## **ADDENDUM ONE**

**DEPARTMENT OF VETERANS AFFAIRS MEDICAL CENTER  
Louis Stokes Medical Center – Wade Park Division  
Hemo Oncology Renovation**

V.A. Project No. 541-10-1001  
HAI Project No. 09005

SUPP. DWG. NO.  
SK-A1

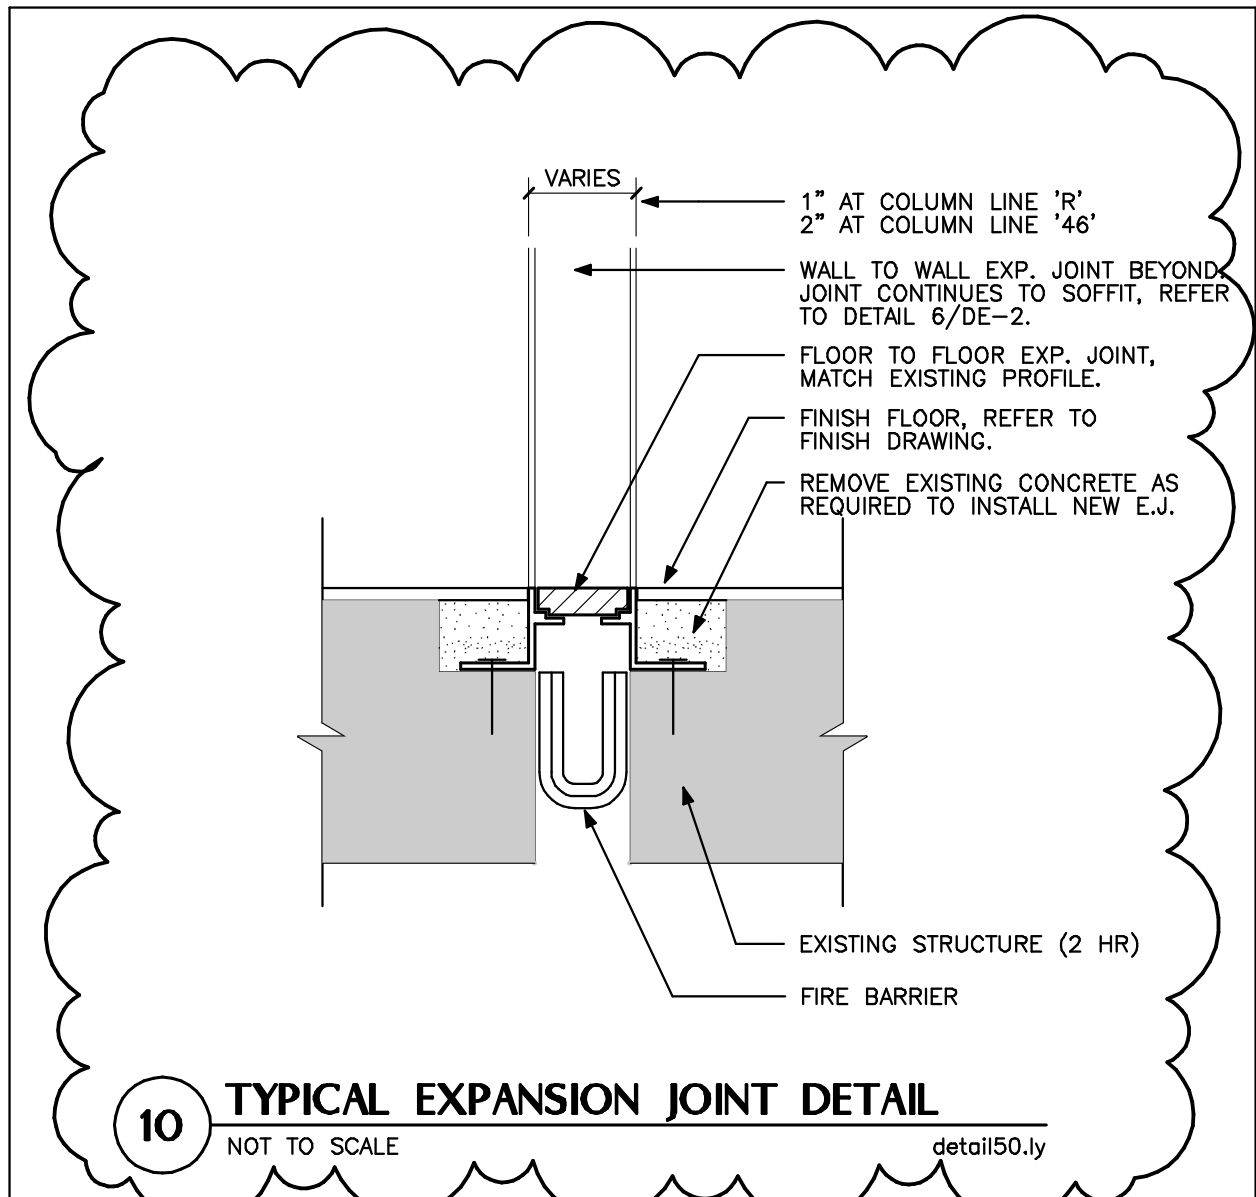
- 1.1 Drawing 1: Demolition Plan:
  - a. Revise drawing to include additional demolition of a door recently added to the area. See Sketch SK-A4.
- 1.2 Drawing 2: Floor Plan:
  - a. Added Keyed Notes #16 and #17 to clarify expansion joint locations. Refer to Sketches SK-A1 and SK-A2.
- 1.3 Drawing DE-3: Details:
  - a. Added Detail #10. Refer to Sketch SK-A3.
- 1.4 Drawing 8: Interior Elevations:
  - a. Revise Interior Elevation #5 to indicate procedure light to be 'VC' (FBO/IBC).
